TVA-SQN-TS-06-03

**SEQUOYAH NUCLEAR PLANT (SQN) - UNITS 1 AND 2 - TECHNICAL SPECIFICATIONS (TS) CHANGE 06-03 "ULTIMATE HEAT SINK (UHS) TEMPERATURE INCREASE AND ELEVATION CHANGES"**

## ENCLOSURE 1

### TENNESSEE VALLEY AUTHORITY (TVA) SEQUOYAH NUCLEAR PLANT (SQN) UNITS 1 AND 2

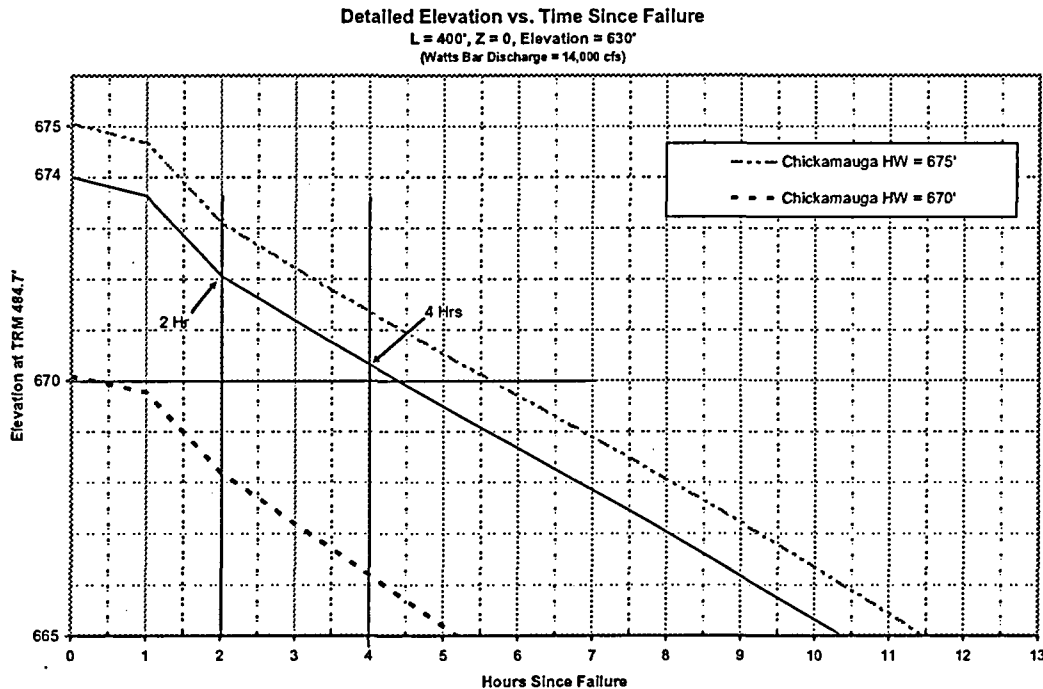
TVA has reviewed the recent ERCW flow balance and flow modeling (performance data). The review concludes that the components flow balanced at a river elevation of 670 feet are capable of supplying cooling water flow to support both short-term and long-term cooling needs following a LOCA and LODD. Also, a lower river level can supply the required minimum safety-related flows to the CCS and CS system heat exchangers without loss of net positive suction head; however, less operating margin exists which impacts operating fouling factors and requires removing equipment from service more frequently for flushing and biocide injections. TVA proposes a minimum river level of 674 feet for this UHS change request. An UHS elevation of 674 feet is conservative at 87°F, with regards to current analyzes and equipment performance data, to support essential heat loads following the accident events and provides at least 4 hours of river level above 670 feet following a LODD event (References 6 and 7). The below figure shows the river elevation change after the LODD. These

results are from Reference 8 with an overlay drawn-down curve for a river elevation starting point of 674 feet. A provision of 4 hours above the 670-foot system flow balance is adequate for compliance with the TS action statement, where the plant would be placed into Hot Standby (Mode 3) and in Cold Shutdown (Mode 5) within the following 30 hours, because lower river levels can supply the required minimum safety-related flow rates.
